# Rezoning Transportation Analysis

Petition Number: 2022-193

Date	Description
3-22-23	First Review (TM)
04-20-23	Second Review (TM)

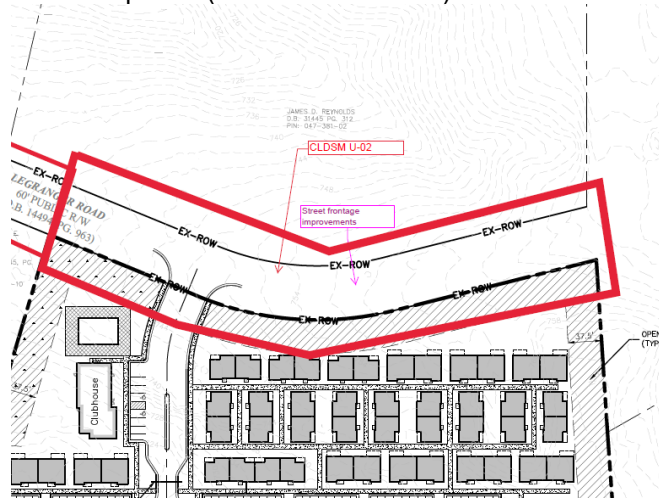
- 3. ~~Revise site plan and conditional note(s) to commit to dedicate a minimum of 28' right of way from the road centerline. The site plan shall label and dimension the right of way from the road centerline.~~

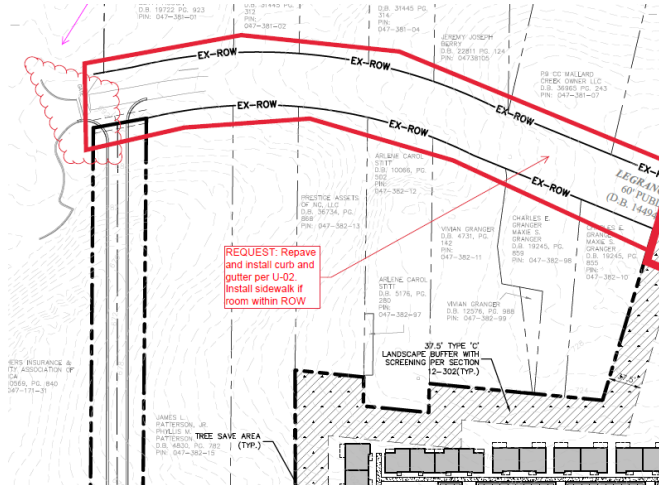
5. ~~Revise site plan and conditional note(s) to commit to reconstructing Legranger to meet CLDSM U-02 standards along sites frontage including sidewalk, curb and gutter. Roadway improvements shall be coordinated with adjacent development (SDRU-2022-00007).~~
